REMARKS

Enclosures: Replacement Figure 2 and 3
Annotated Sheet Showing Changes to Figure 2 and 3

FIG. 2

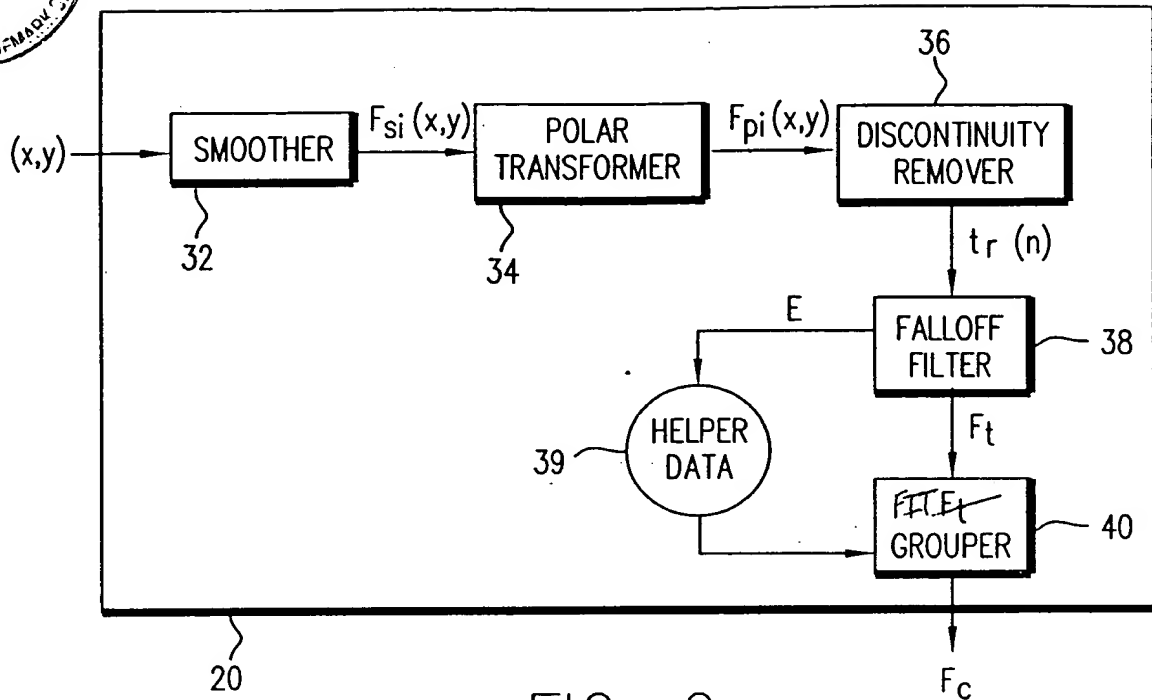
The Examiner objected to the drawings as failing to comply with 37 CFR 1.84(p)(4) because reference character "40" had been used to designate both an F_t grouper in the Figure 2 and a fit grouper in the specification. The attached sheet of drawings, which includes corrected informal Figure 2, replaces the original Sheet 2.
